Our Ref: R/2023/9
File No: 2023/154349
Your Ref: SSD-32766230

**Advice on Environmental Impact Statement – 35-75 Harrington Street, The Rocks
– SSD-32766230**

Figure 2: Level 2 plan (DA-2001[01]) with landscape areas shown in magenta

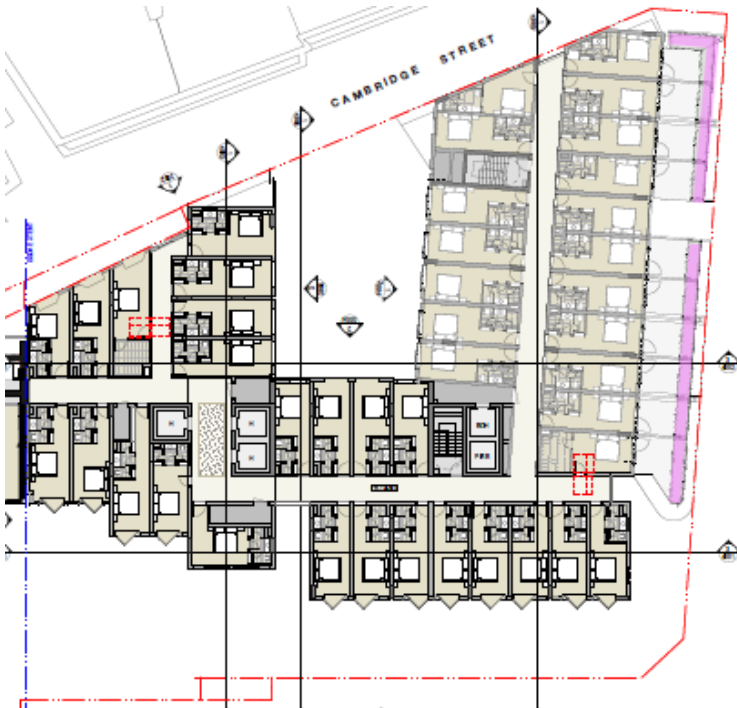
The Level 2 plan includes perimeter planters to the northern edge of 11 hotel rooms that is not included in the landscape plans (refer to Figure 2 below).

Figure 3: Level 6 plan (DA-2002[01]) with landscape areas shown in magenta

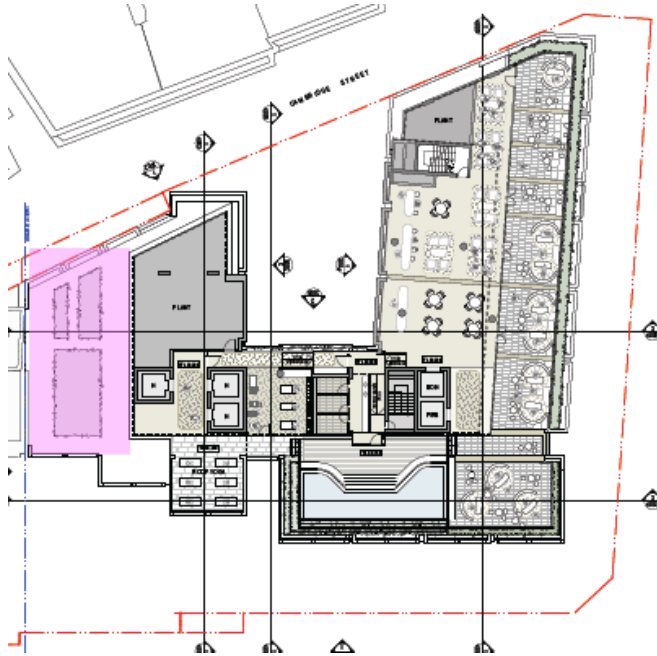
The Level 6 Architectural plans indicates areas of planting to the south of plant areas (Figure 3 below) that are not included in the landscape plans.

Figure 4: Landscape Level 6 plan (L404 [A]) with landscape areas shown in magenta that are not included on architect plans

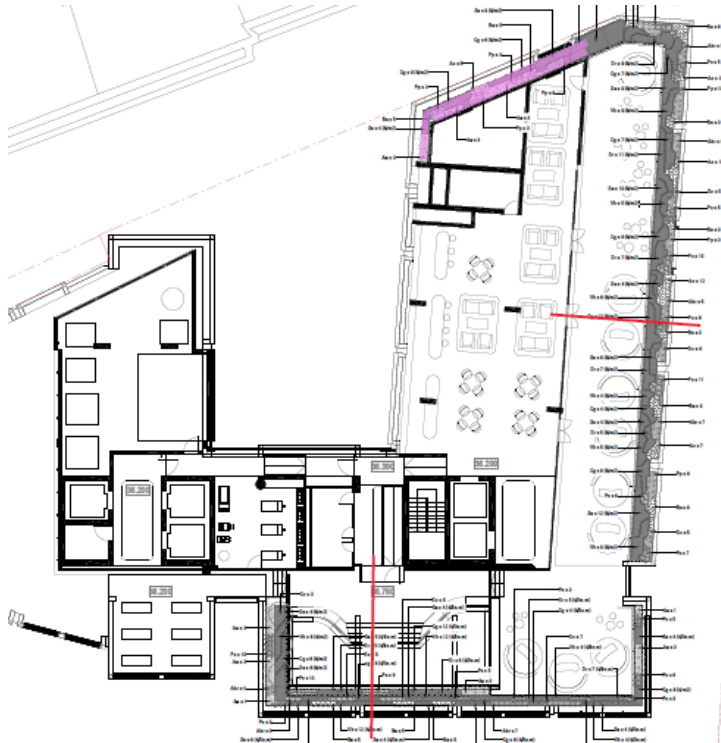
While the landscape plan include planting on the western edge of Level 6 that are not shown on the architect plan.
